APPENDIX D

ANALYSIS OF MODIFICATIONS SOUGHT BY SUBMITTERS TO SPECIFIC PROVISIONS OF THE VARIATION

49 Te Pūtahi Ladies Mile Zone

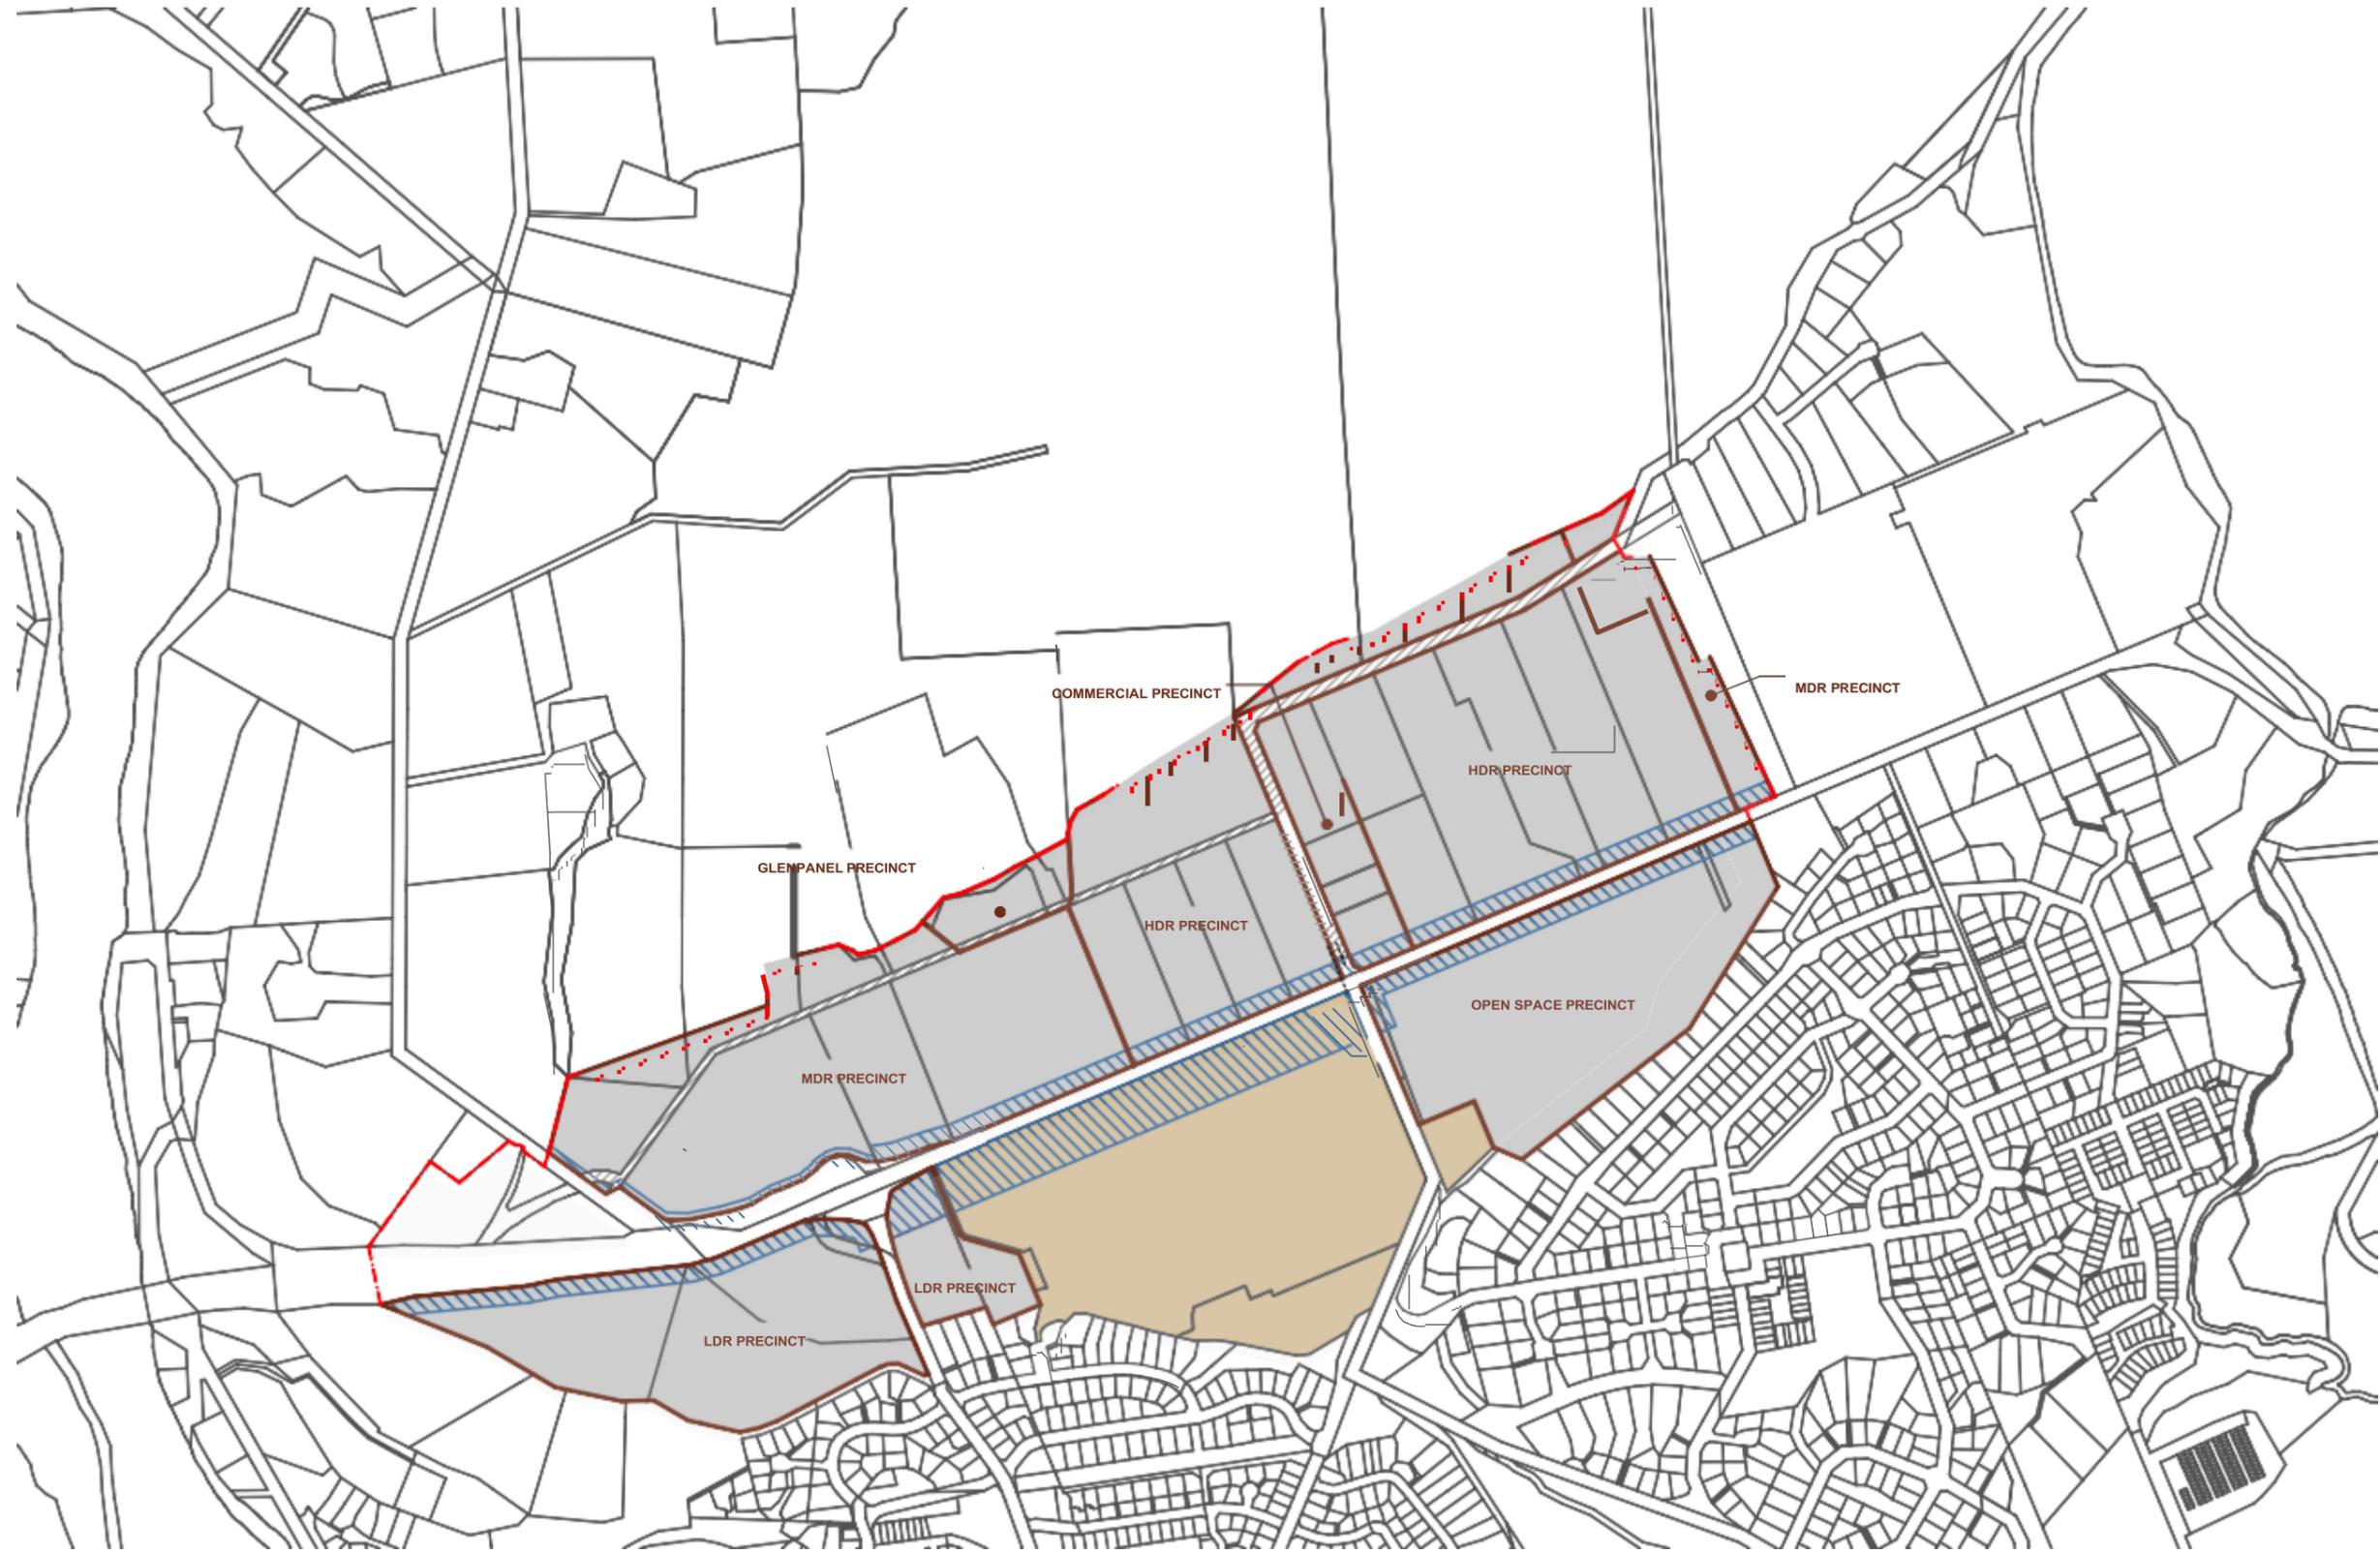
#101 D Finlin	That the Medium Density Residential Precinct located on the eastern side of the submitter's land (21 and 25 McDowell Drive legally described as Part Section 49 and 54, Block III, Shotover Survey District and Lot 1 DP475308), (Sub Area G) be widened to a consistent width for the length of that boundary to ensure the land can be reasonably used and developed.

#101 D Finlin	That the Open Space area in the northern

corner of the submitter's land (21 and 25 McDowell Drive legally described as Part Section 49 and 54, Block III, Shotover Survey District and Lot 1 DP475308) be deleted from the Structure Plan, and that such open spaces be provided for through subsequent development proposals (Rule 49.5.15).

#101 D Finlin	That if the land that is located to the east of the Variation that is within the submitter's ownership is not included in the Medium Density Residential precinct, then that land should offset all open space reserve requirement for development of the remainder of the submitters land.
